NOTICE REGARDING CORNER FLUSH BOLTS

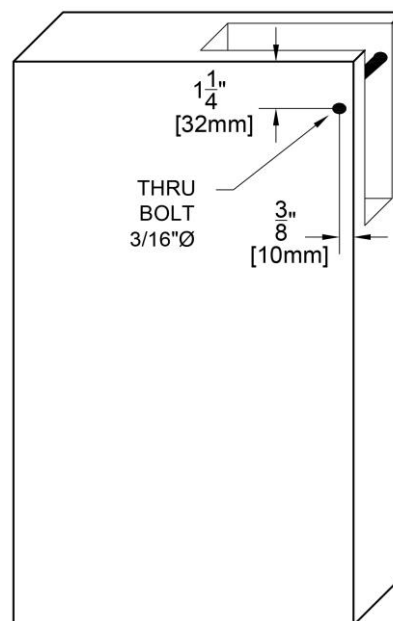
It is important to know that **the adjacent door faces of corner flush bolts** will tend to flare open with time. This situation is due to extremely weakened door faces by thinness in this area.

Before

After

To remedy this situation we suggest adding a thru bolt when installing the corner flush bolt.

In fact, the thru bolt will maintain firmly the two exterior door faces in their original position. Please refer to the technical drawing when installing the thru bolt.
